Contract #: 04-0120F4Cty: SF/ALA Rte: 80 PM: 13.2/13.9File #: 69.25B**QUALITY ASSURANCE -- NON-CONFORMANCE REPORT****Location:** Changxing Island, Shanghai, P.R. China**Report No:** NCR-000544**Prime Contractor:** American Bridge/Fluor Enterprises, a JV**Date:** 18-Dec-2009**Submitting Contractor:** Zhenhua Port Machinery Company, Ltd (ZPMC), Changxing Island**NCR #:** ZPMC-0517**Type of problem:**

Reference Description: Excessive Weld Size, T-rib Splice, L6W**Description of Non-Conformance:**

Job Name: SAS Superstructure
Document No: 05.03.06-000505

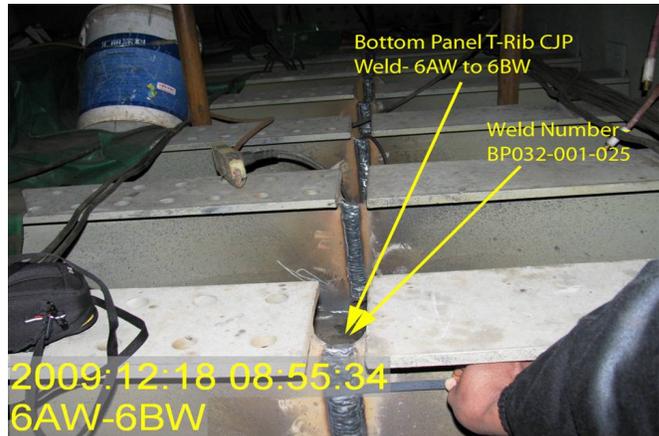
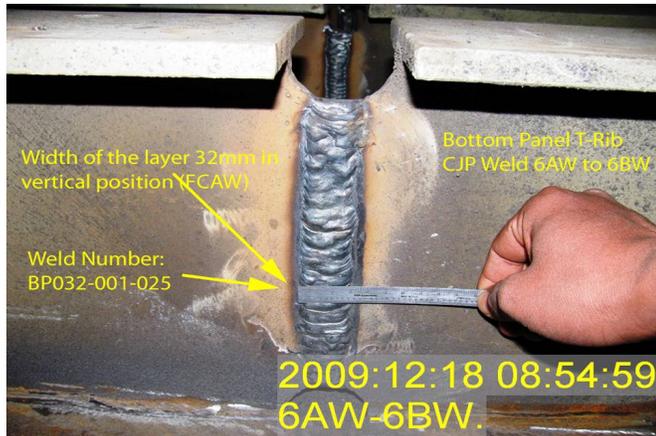
During a random visual inspection at Segments 6AW to 6BW for dimension verifications of T-Stiffeners, the Caltrans Quality Assurance (QA) Inspector observed ZPMC in-process of welding T-Stiffeners that connect the segment splice at 6AW to 6BW. The non-conforming item documented during the welding process was the excessive width of a vertical single weld pass, utilizing the Flux Core Arc Welding (FCAW) process. Additional information identifying the non-conforming issues is listed below.

- The vertical weld is identified as: BP032-001-025
- The welding process is identified as: FCAW
- The Weld is a Complete Joint Penetration (CJP) joint.
- The maximum vertical single pass width for FCAW is 25mm.
- The maximum root opening between parts shall not exceed 5mm
- The approved weld procedure specification (WPS) is identified as: WPS-B-T-2233-B-U2-F
- The approved WPS allows a root opening of 5mm maximum.
- The 6AW to 6BW segment splice weld is identified as: OBW6B-003
- The vertical T-Stiffener weld is located at panel point 41 (PP41).

Approved WPS # WPS-B-T-2233-B-U2-F; "states the maximum root opening is 5mm."

AWS D1.5 (02) Section 3.3.2.1; The root opening between parts shall not exceed 5mm [3/16 in.].

AWS D1.5 (02) Section 4.14.1.5 FCAW; "The thickness of the weld layers in groove welds, except root and surface layers, shall not exceed 6 mm [1/4 in.]. When the root opening is 12 mm [1/2 in.] or greater, a multiple-pass split-layer technique shall be used. When the width of a layer of a groove weld in the flat, horizontal, or overhead position is 16 mm [5/8 in.] or greater, a multiple-pass split-layer technique shall be used. When welding in the vertical position, a split-layer technique shall be used when the width of the layer exceeds 25 mm [1 in.]."

Submit a repair procedure to the engineer for approval. A response for the resolution of this issue is expected within 7 days.

ZPMC acknowledges that the weld pass width exceeded the allowable limits and has issued an internal NCR to the Production department to prevent future occurrences. ZPMC is providing NDT documentation to show that the welds are acceptable. Based on this ZPMC requests closure of this NCR.

The documentation received is sufficient to close this NCR.
